<b>JRPP No:</b>	2010NTH035
<b>DA No:</b>	DA10/0800
<b>PROPOSED DEVELOPMENT:</b>	Development Application for Cobaki Estate subdivision of precinct 1 and 2 comprised of 475 residential lots (including 1 residual lot) and lots for drainage, open space and urban infrastructure (JRPP) at Lot 1 DP 562222; Lot 2 DP 566529; Lot 1 DP 570077; Lot 1 DP 823679; Lots 46, 54, 55, 199, 200, 201, 202, 205, 206, 209, 228, 305 DP 755740, No. 73 Sandy Lane; Lot 1 DP 570076 Piggabeen Road, Cobaki Lakes
<b>APPLICANT:</b>	Leda Manorstead Pty Ltd
<b>REPORT BY:</b>	Tweed Shire Council

## Assessment Report and Recommendation

**FILE NO: DA10/0800**

Development Application DA10/0800 for a Cobaki Estate subdivision of precinct 1 and 2 comprised of 475 residential lots (including 1 residual lot) and lots for drainage, open space and urban infrastructure (JRPP) at Lot 1 DP 562222; Lot 2 DP 566529; Lot 1 DP 570077; Lot 1 DP 823679; Lots 46, 54, 55, 199, 200, 201, 202, 205, 206, 209, 228, 305 DP 755740, No. 73 Sandy Lane; Lot 1 DP 570076 Piggabeen Road, Cobaki Lakes

**Figure 6:** Threatened flora records as illustrated in the final Site Revegetation and Restoration Plan dated October 2010 documentation for MP06\_0316. Note the central clump containing 4 stems.

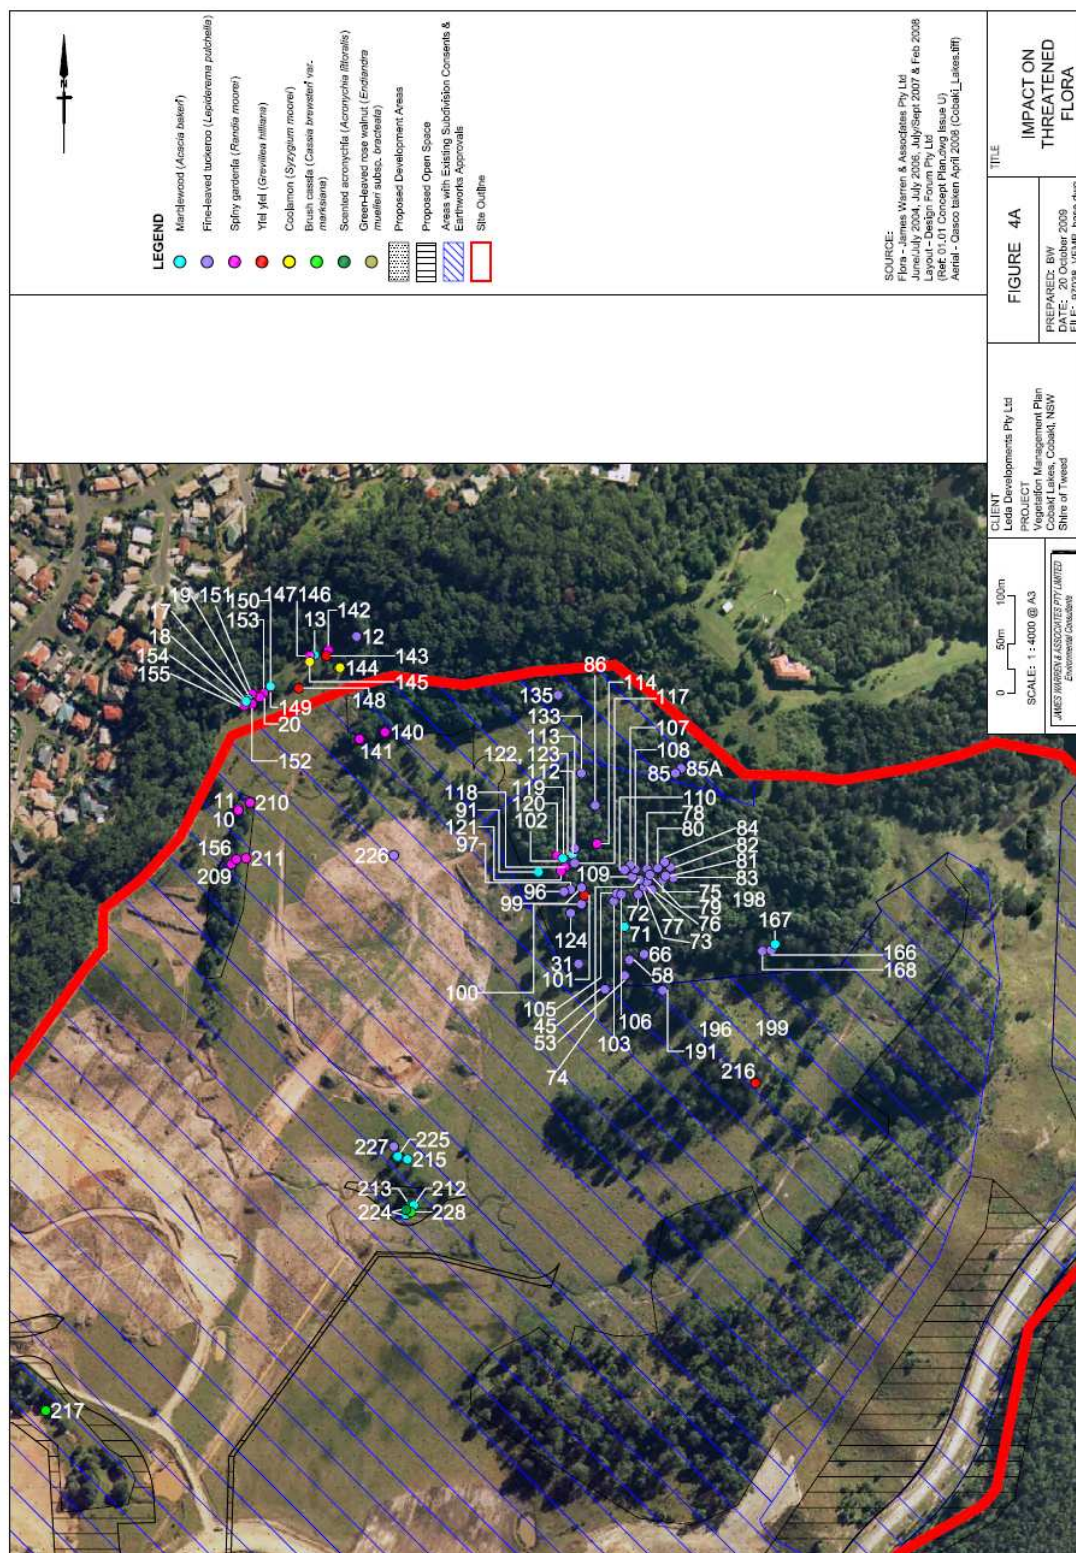
The net result for Precinct 1 provides for two small, disjunct linear parcels that will be subject to significant edge effects and difficult to restore, manage and maintain. The covenant area within the public park does not meet the commitment to restore the surrounding area with rainforest species and does not provide adequate protection for significant threatened rainforest flora, in particular the one stem of *Acronychia littoralis*.

It is also apparent that additional threatened species in the vicinity of the covenant area have been lost during the Concept Plan process, as evidenced by subsequent versions of the SRRP (Figures 6 and 7 below). This does not give certainty to the commitment for retention and restoration.

Since the proponent committed (within the Concept Plan approval) to commencement of rehabilitation works prior to registration of any plan of residential subdivision for adjacent land, site specific management plans and restoration works have been conditioned for Areas shown as 1, 2, 3, 13 and 4. Such areas were already primarily to be protected and restored in accordance with previous Tweed Shire Council consents for which earthworks and clearing has been undertaken. This aspect has been conditioned.
